From: Kris pastoriza [<mailto:krispastoriza@gmail.com>]
Sent: Sunday, December 3, 2017 12:24 PM
To: Monroe, Pamela
Subject: Fwd: Exception Request granted

From: **Kris pastoriza** <krispastoriza@gmail.com>
Date: Thu, Nov 30, 2017 at 11:05 AM
Subject: Exception Request granted
To: "Esterberg, Melodie"

DOT has granted exception requests #3 (Rev. 4) and #4 (Rev. 4) without an accepted survey. The survey submitted was a draft, and I note, for Easton's 805 rods of undetermined ROW, that a surveyor drawing a dashed line for prescriptive ROW is neither legal nor adequate proof of easement. Nor was this draft survey placed on the Exception Request maps, which still contain the rejected survey widths.

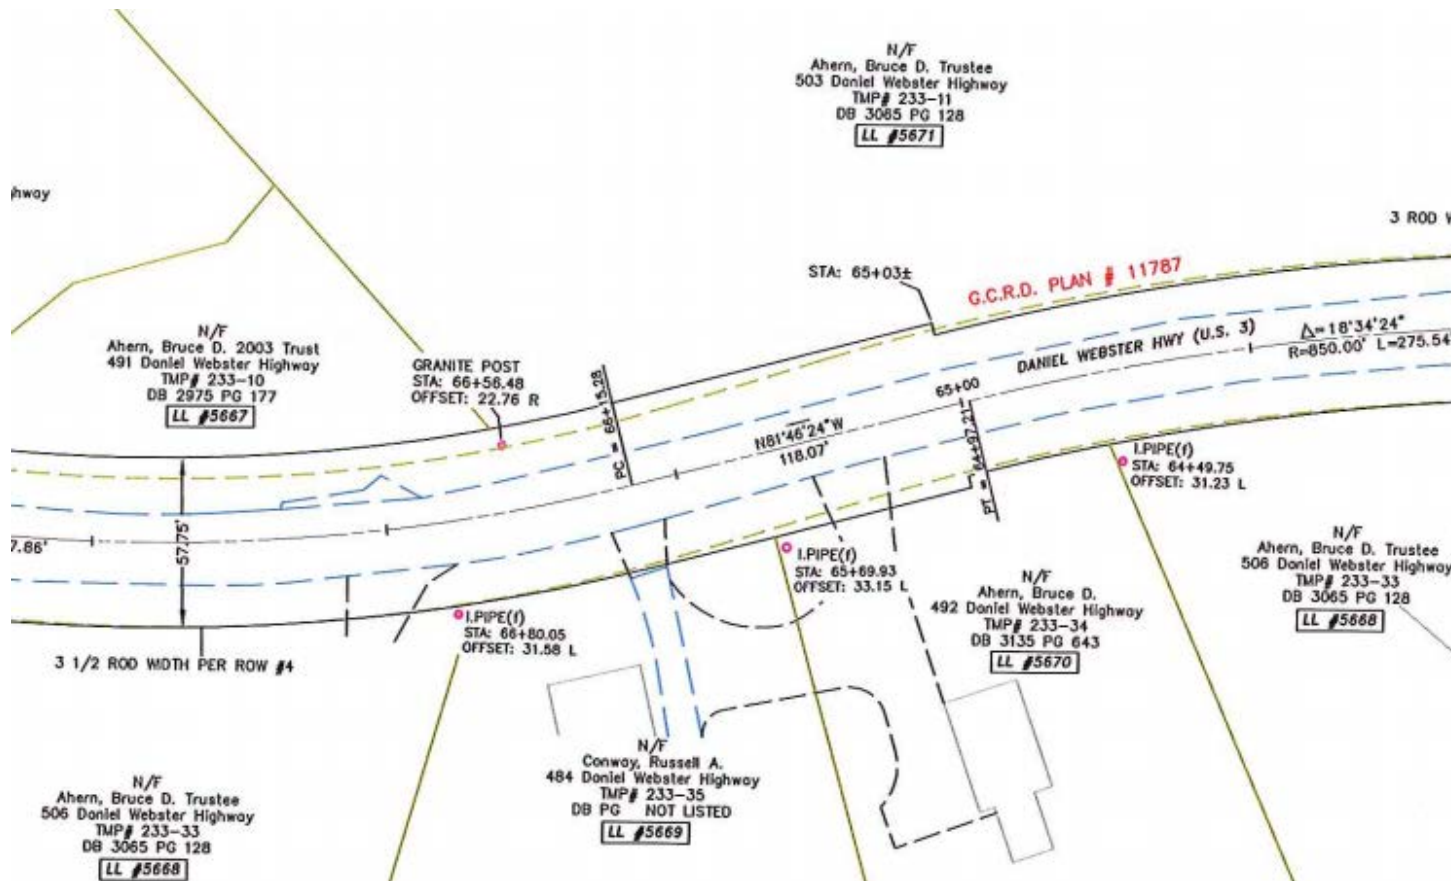
The surveyors have clearly referenced the ambiguous survey standards of the Sept. 5, 2017 meeting, rather than those of earlier documents calling for complete surveys that include all pertinent information and reference Lan standards:

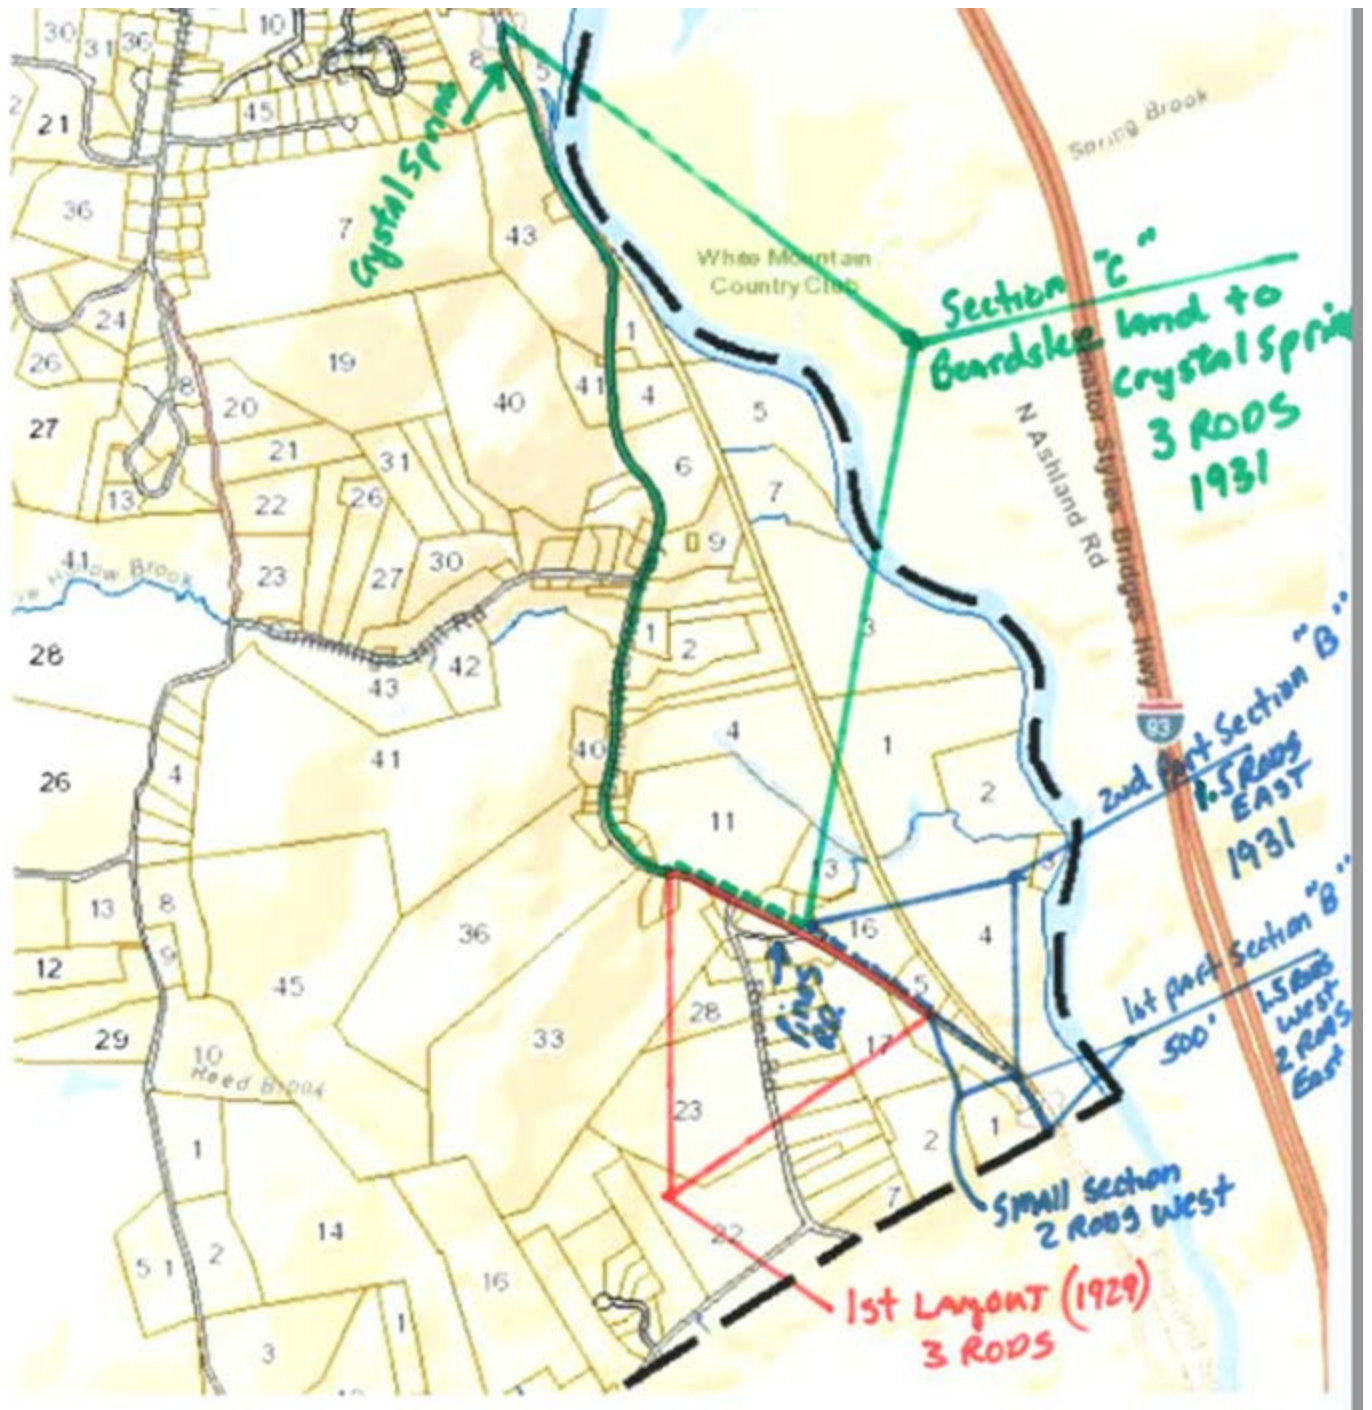
The survey appears to show an incorrect 3 1/2 rod ROW below, where the 1929 3 rod layout prevails. ROW #4 referenced below covers an area just north of the Bridgewater/Plymouth boundary. This 3 rod width is supported by the Granite Post below, one of the few monuments shown. Do the surveyors have metal detectors, measuring devices and compasses?

If I am reading the map correctly, Bruce Ahern lives where River Rd. meets Route 3, around Lot 11 on the map below, within the 3 rod sections of the 1929 and 1931 layouts.

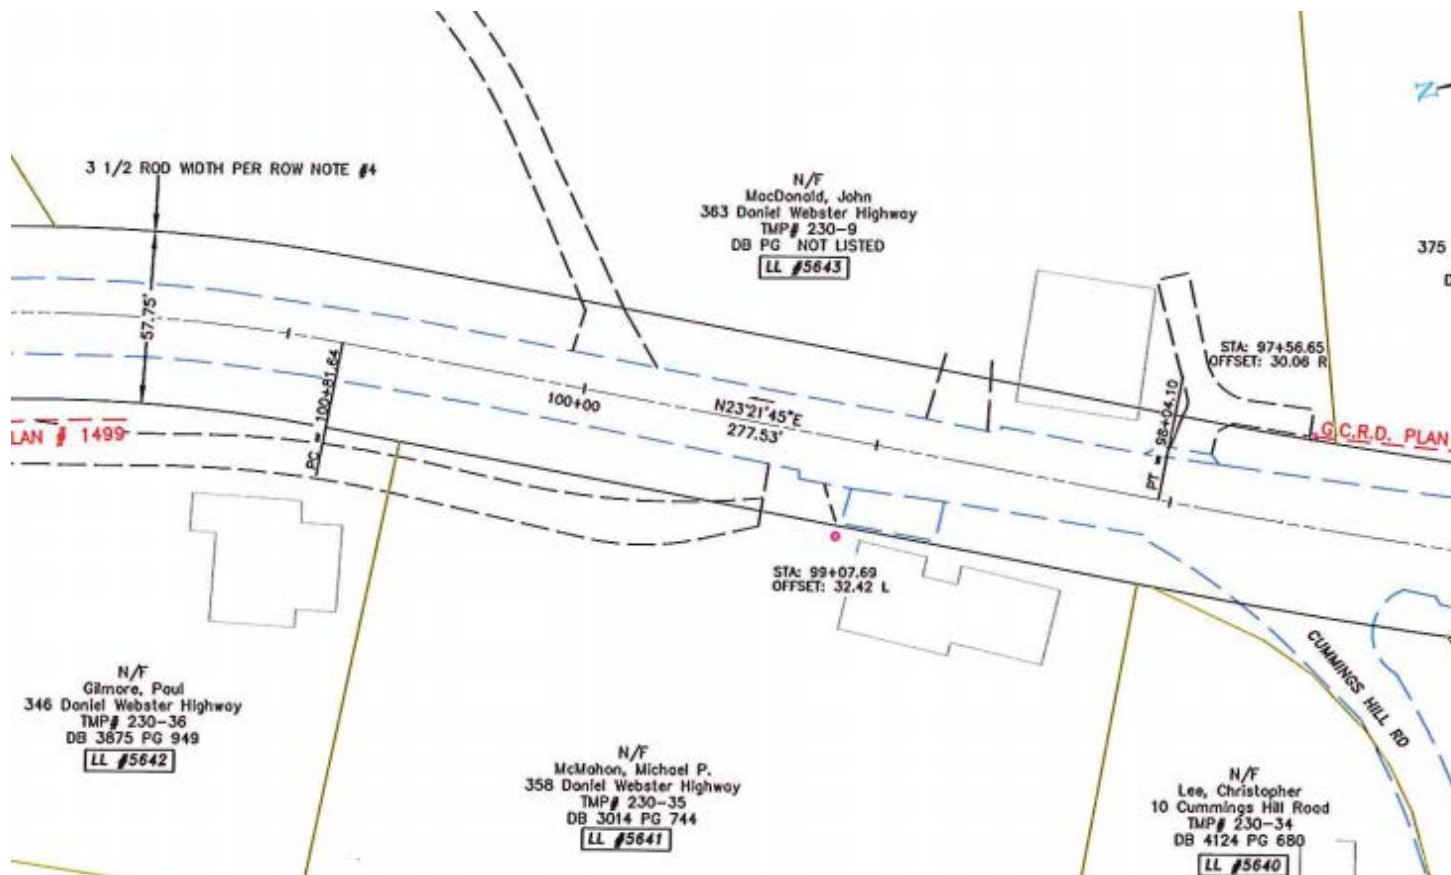
The same 3 rods appears to be what should be shown on the survey page below, at Cummings Hill Rd., which is north of River Rd. and shown as per 1931 Section C. on the map above.

Why is 3 1/2 rods shown from point 65.03 north to the end of the survey?

Below left: ER #3, Rev.3, (4 rod ROW shown in both Exception Requests) Below right: ER #3, Rev. 4. (just accepted by DOT.)

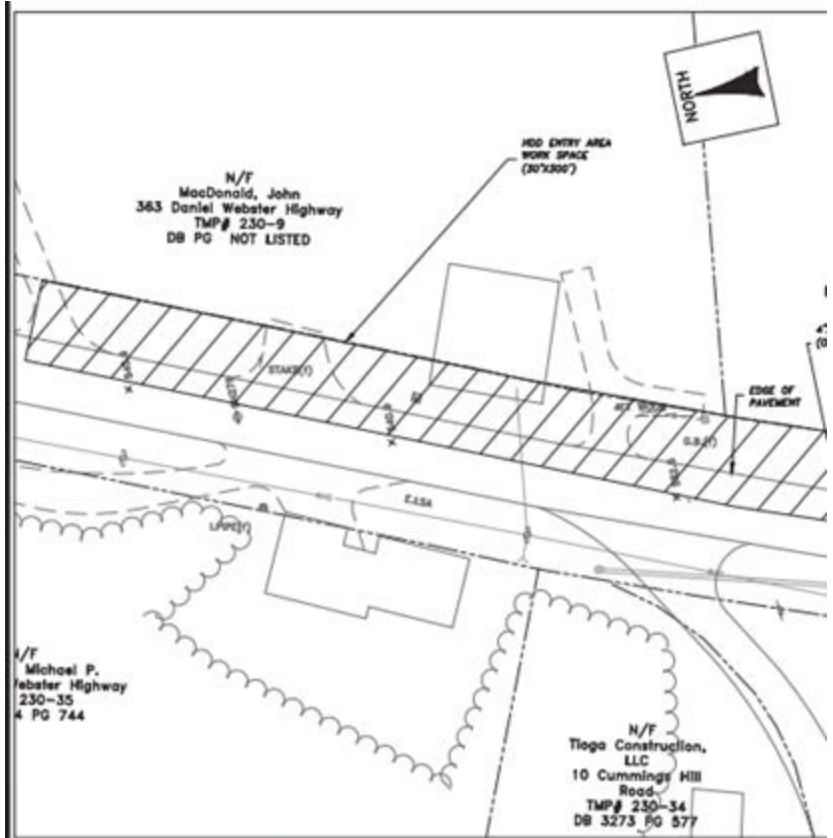
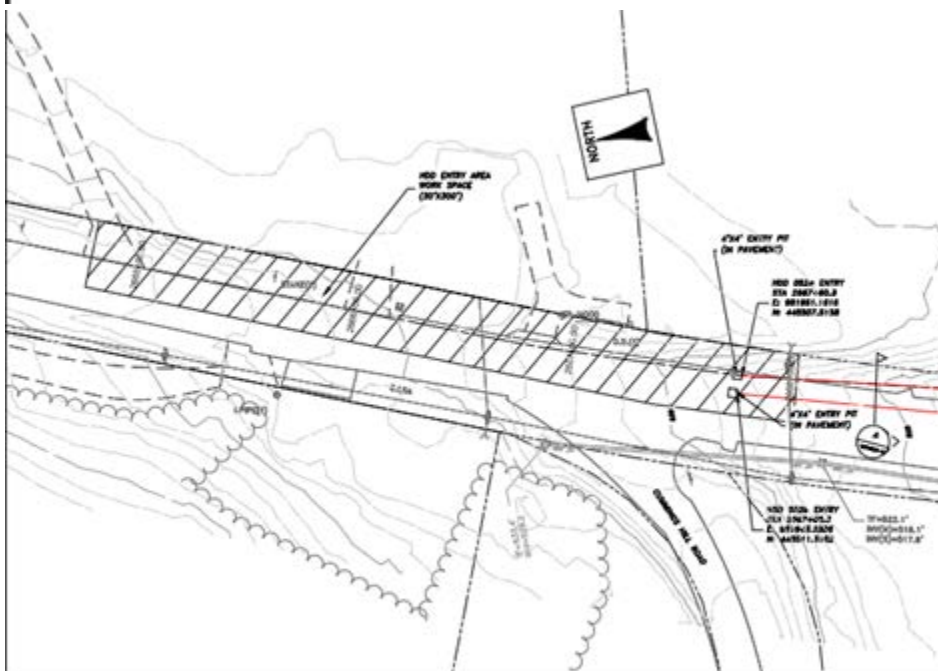
What happened to the houses?
